CONSTRUCTABILITY
FIELD REVIEW

ROAD SAFETY AUDIT REVIEW

INTERSTATE 24
L.M. 14.67 TO L.M. 16.06
DAVIDSON COUNTY

LAYOUT SHEET
INTERSTATE 24
L.M. 15.93 TO
L.M. 16.06

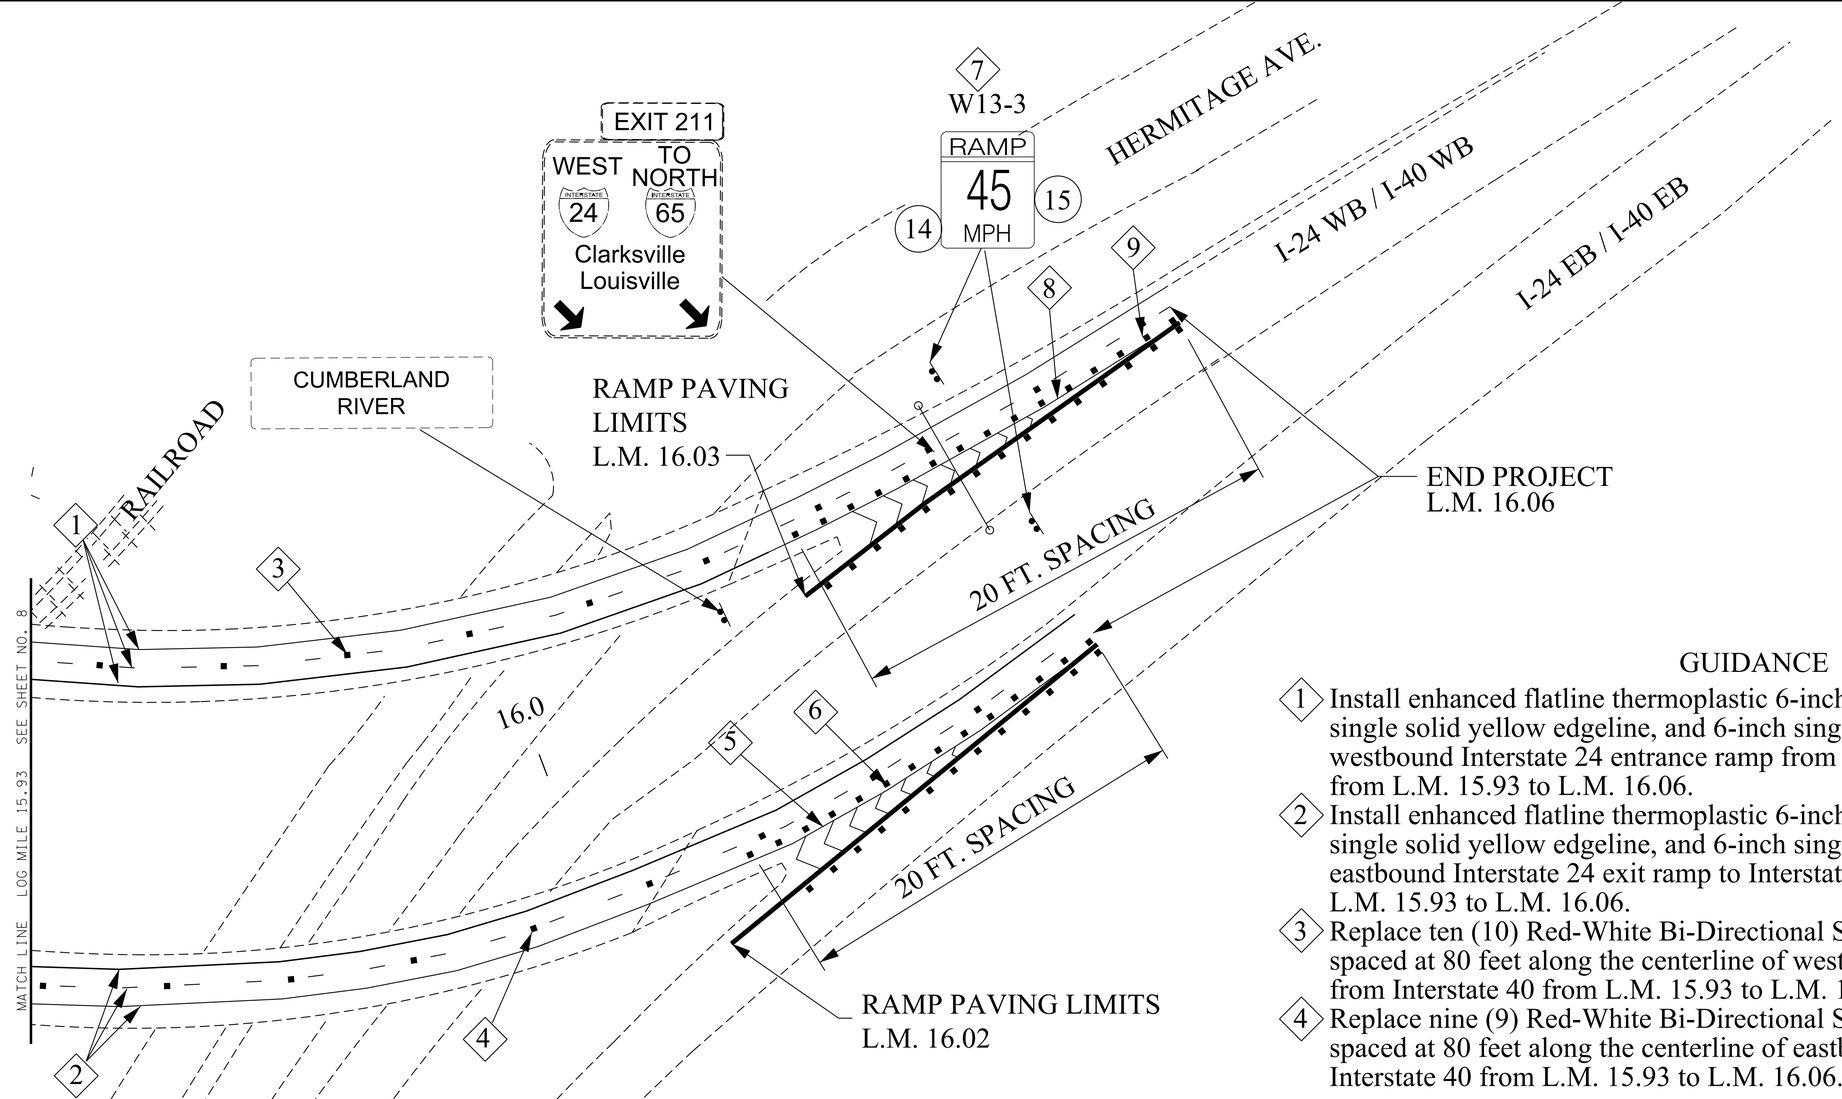
1. Install enhanced flatline thermoplastic 6-inch single solid white edgeline, 6-inch single solid yellow edgeline, and 6-inch single broken white skip line along westbound Interstate 24 entrance ramp from Interstate 40 to match existing, from L.M. 15.93 to L.M. 16.06.

2. Install enhanced flatline thermoplastic 6-inch single solid white edgeline, 6-inch single solid yellow edgeline, and 6-inch single broken white skip line along eastbound Interstate 24 exit ramp to Interstate 40 to match existing, from L.M. 15.93 to L.M. 16.06.

3. Replace ten (10) Red-White Bi-Directional Snowplowable Reflective Markers spaced at 80 feet along the centerline of westbound Interstate 24 entrance ramp from Interstate 40 from L.M. 15.93 to L.M. 16.06.

4. Replace nine (9) Red-White Bi-Directional Snowplowable Reflective Markers spaced at 80 feet along the centerline of eastbound Interstate 24 exit ramp to Interstate 40 from L.M. 15.93 to L.M. 16.06.

5. Install 24-inch diagonal chevron channelization plastic pavement marking spaced at twenty (20) feet surrounded by enhanced flatline thermoplastic 8-inch single solid white edgelines, along the eastbound Interstate 40 exit ramp gore from Interstate 24 to match existing.

6. Replace twenty seven (27) Red-White Bi-Directional Snowplowable Reflective Markers spaced at 20 feet along the diagonal chevron channelization pavement markings along eastbound Interstate 40 entrance ramp gore from Interstate 24.

7. Remove and replace both of the existing Advisory Ramp Speed (45 M.P.H) Signs (W13-3) (36”x48”) on both sides of eastbound Interstate 24 entrance ramp.

8. Install 24-inch diagonal chevron channelization plastic pavement marking spaced at twenty (20) feet surrounded by enhanced flatline thermoplastic 8-inch single solid white edgelines, along the westbound Interstate 40 exit ramp gore to Interstate 24 to match existing.

9. Replace thirty (30) Red-White Bi-Directional Snowplowable Reflective Markers spaced at 20 feet along the diagonal chevron channelization pavement markings along westbound Interstate 40 entrance ramp gore to Interstate 24.
